RE: **(04/07/20) 41 Salem St**

Ref: 41 Salem St. Proposed demo & construction of 3 units.

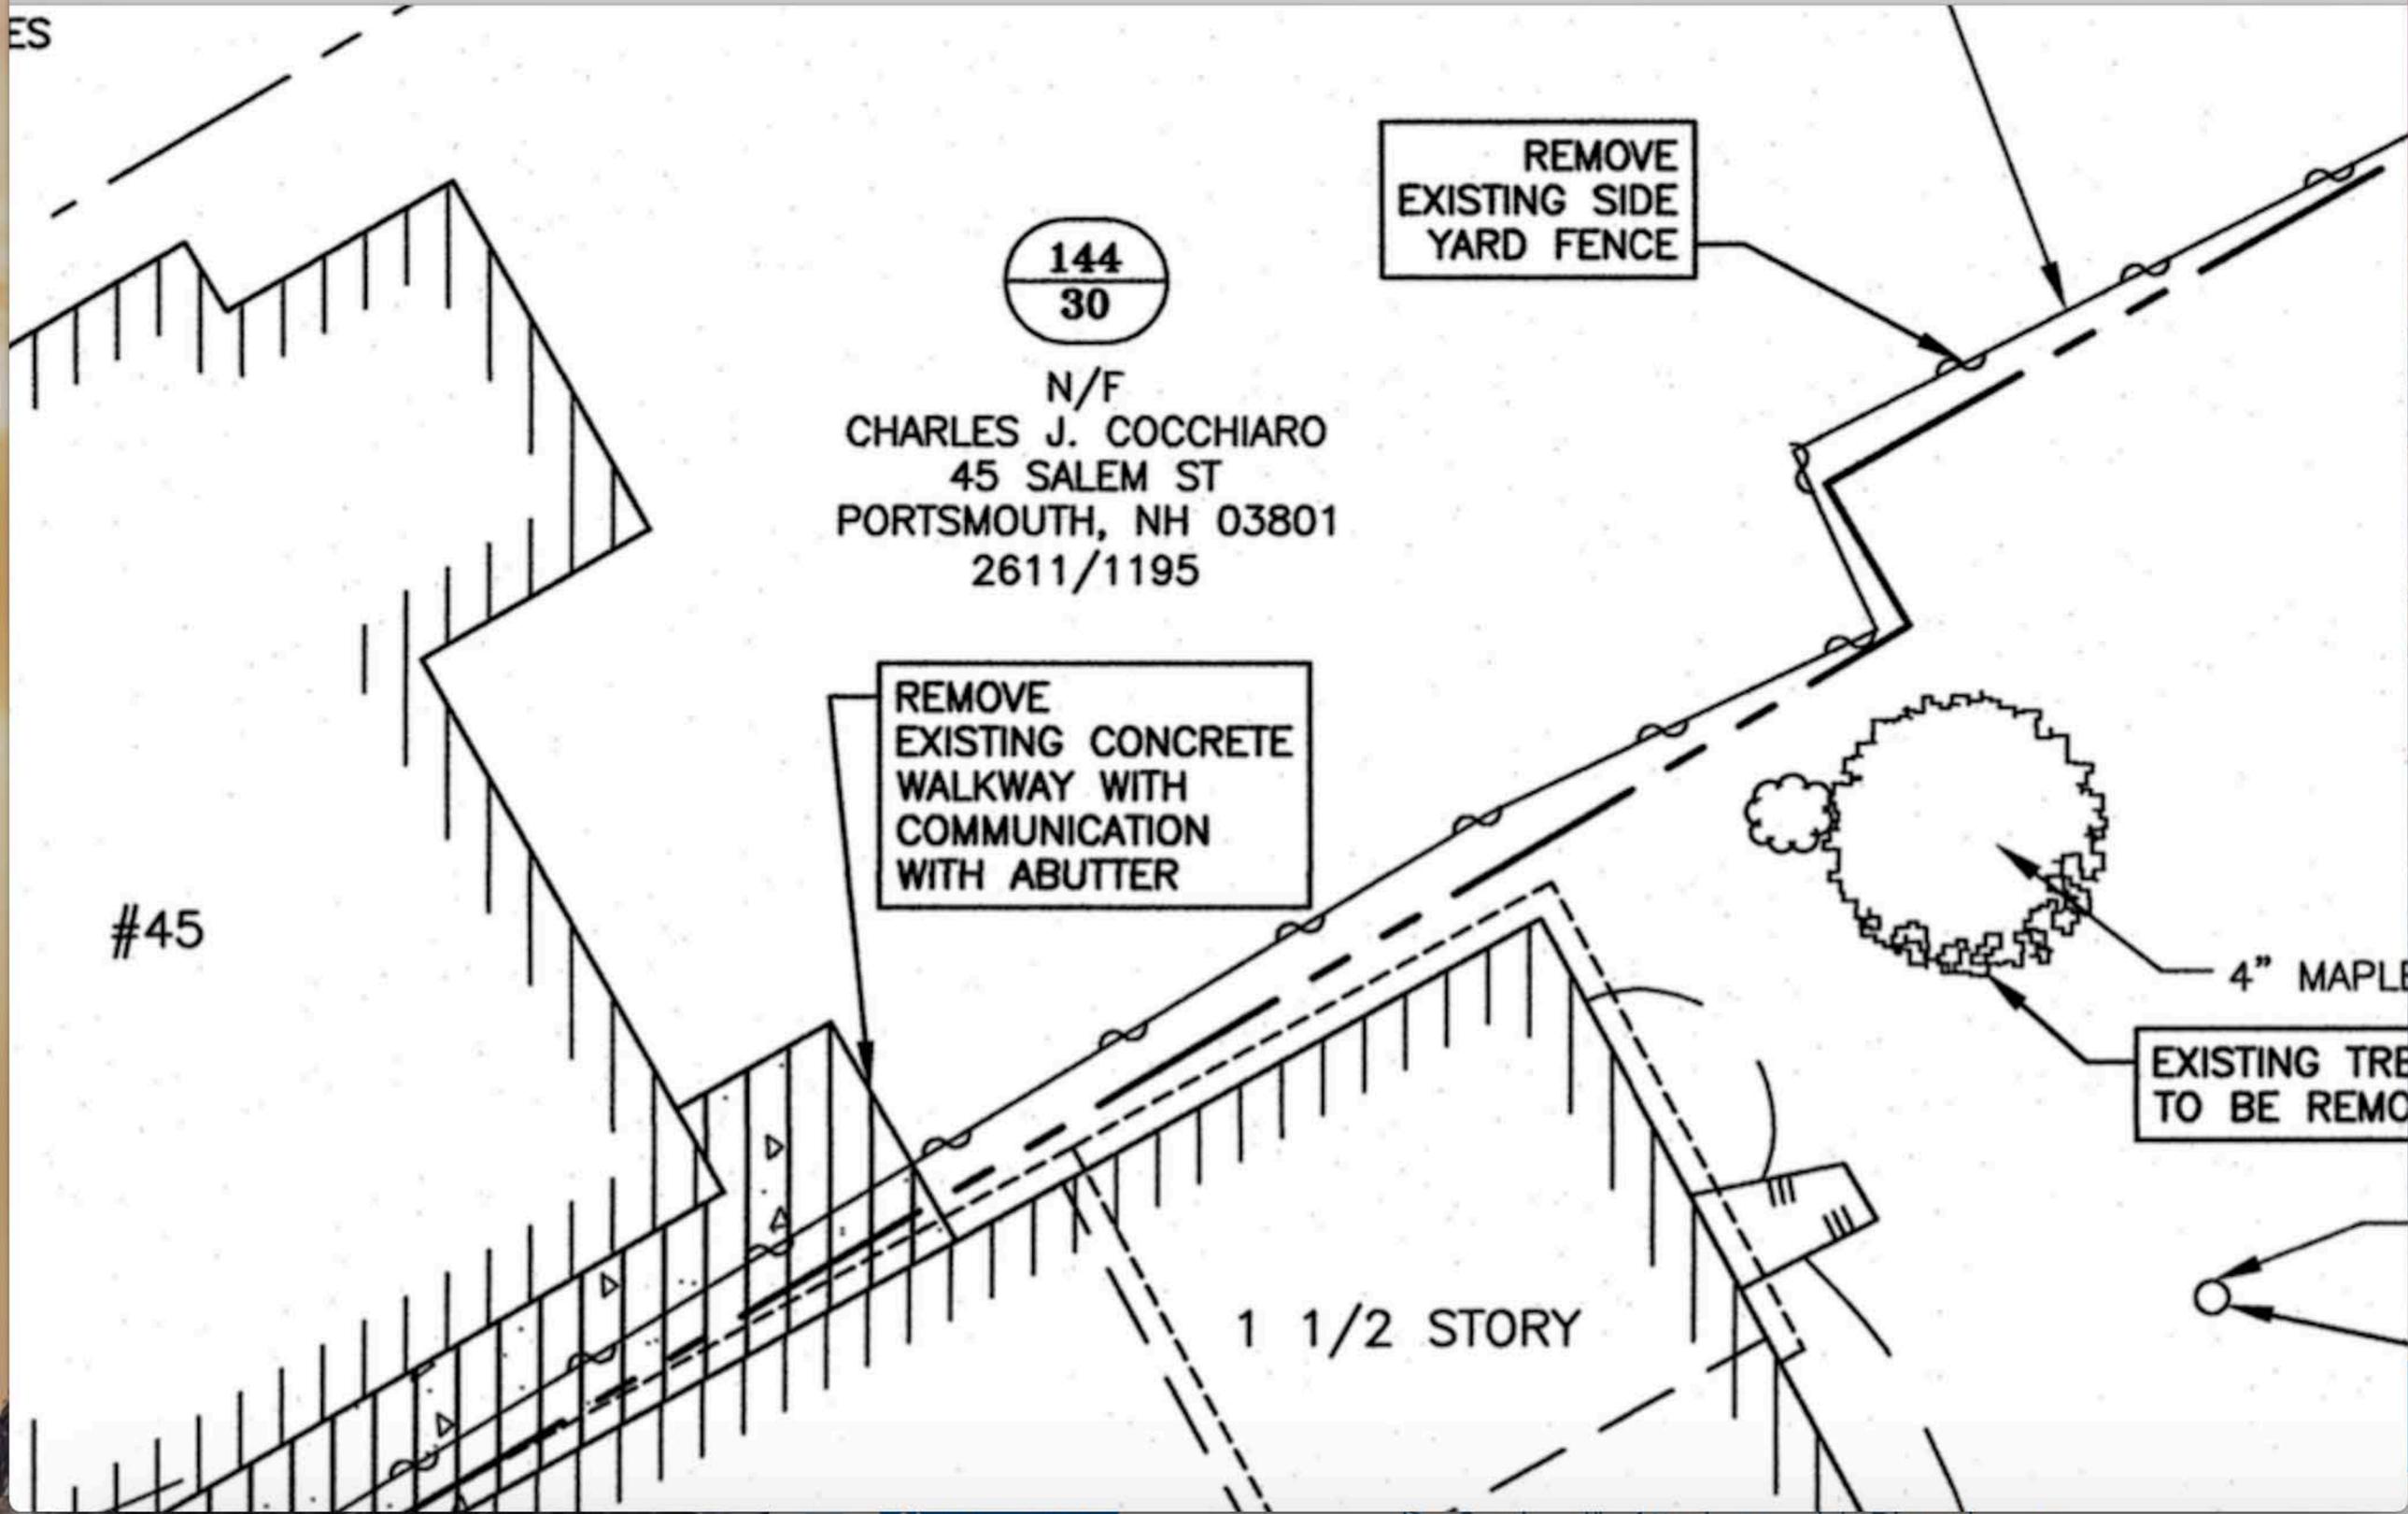
1). It is shown that a 12" city owned Maple tree will be removed as part of the new construction. I would like to understand how a tree of that size and scale will be replaced. In the plantings diagram it states a 4-6" tree of the Maschia Amurensis "Starburst" will be replaced.

Will the developer be responsible for maintaining this tree for the minimum period of 24 months to assure that it survives? I placed a call to the city arborist but have heard nothing as of Tuesday 10:00 Am
